July 23, 2001
NOC-AE-01001141
File No.: G09.07
10CFR50.71
STI: 31317943

South Texas Project
Units 1 and 2
Docket Nos. STN 50-498, STN 50-499
Fire Hazards Analysis Report, Amendment 13

Fire Hazards Analysis Report Summary of Changes Made under the Provisions of 10CFR50.59

Instruction Sheet for
STP Final Hazards Analysis Report – Amendment 13)

FIGURE 3-34

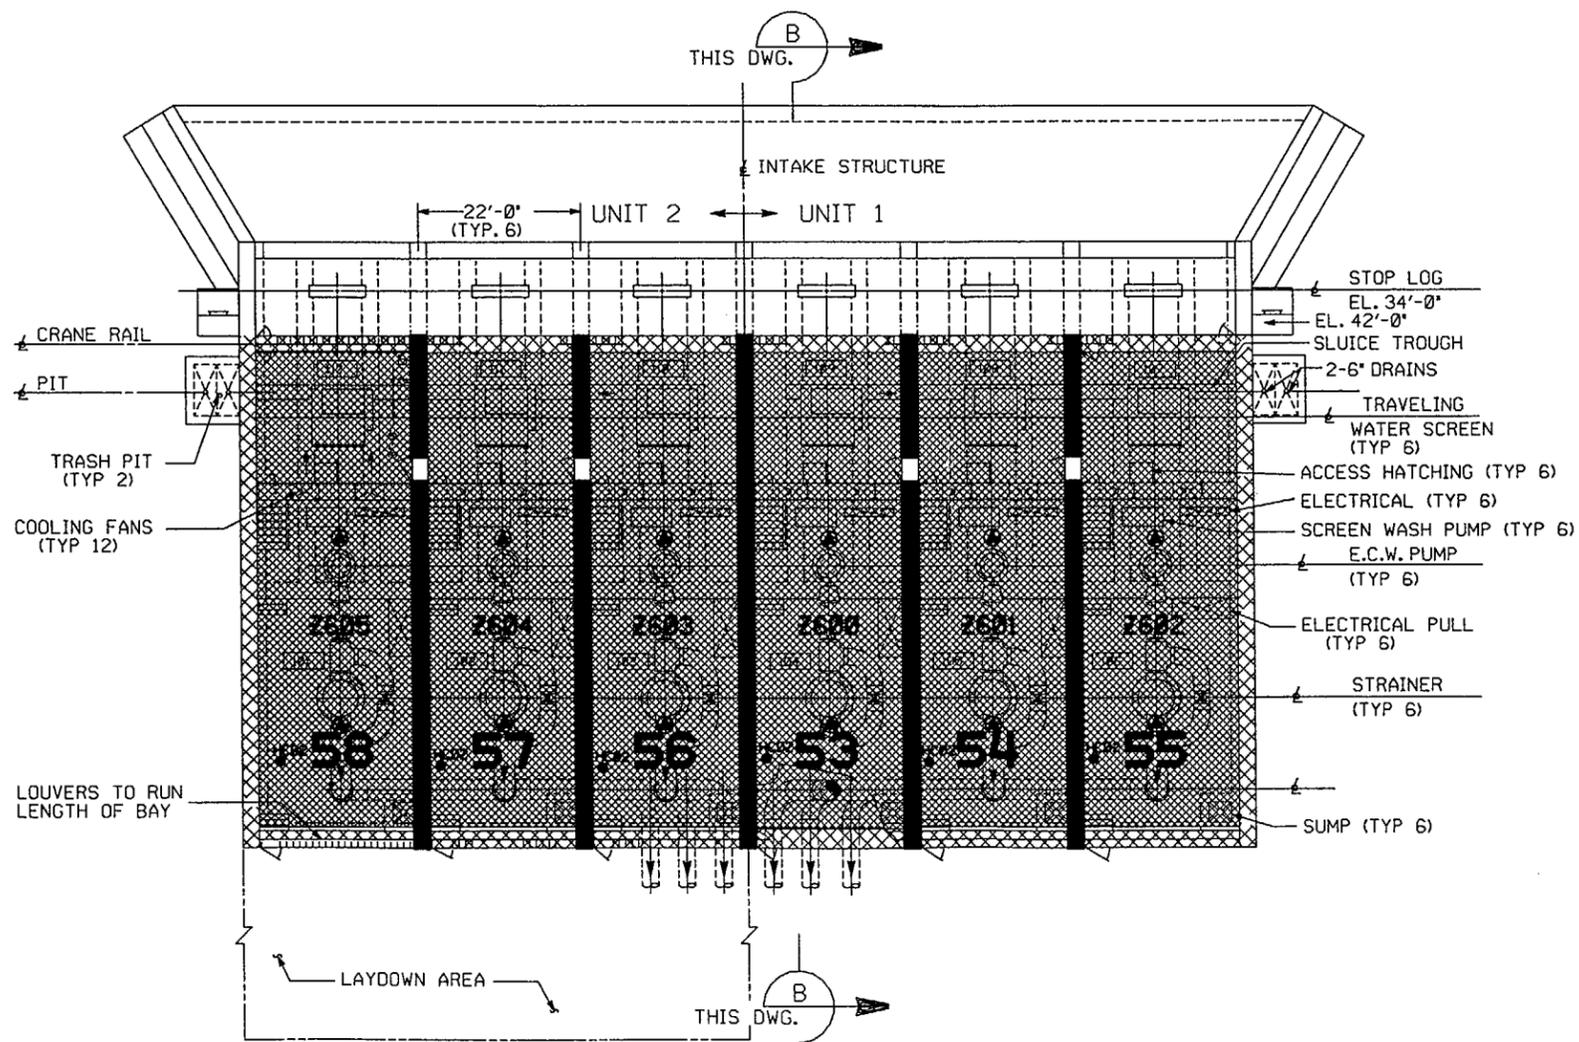
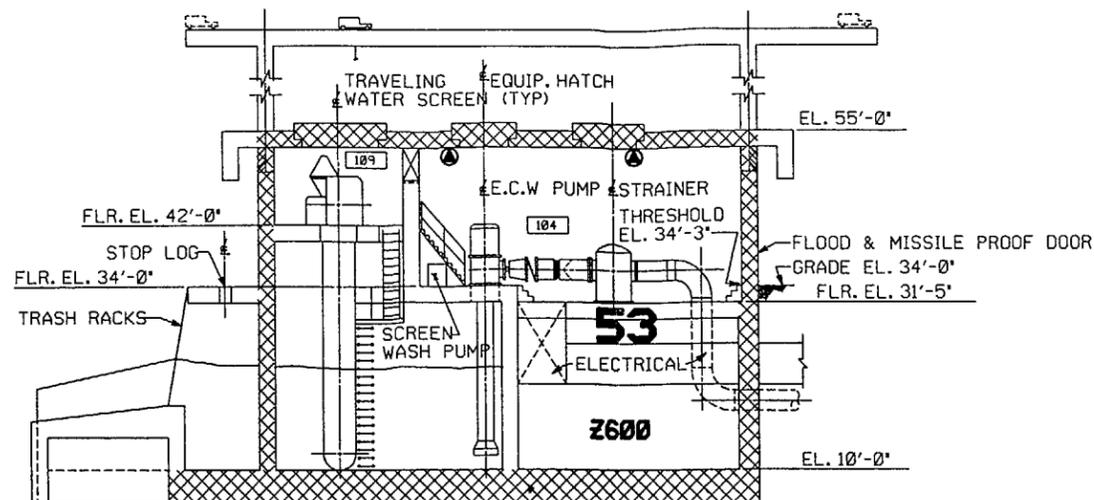
1. Corrected typographical error on Page 3.10-3 and deleted two blank pages.
[3.10.4] (CN-2484) {NEI 98-03}
2. Corrected editorial error in Figure 3-34. (CN-2496)
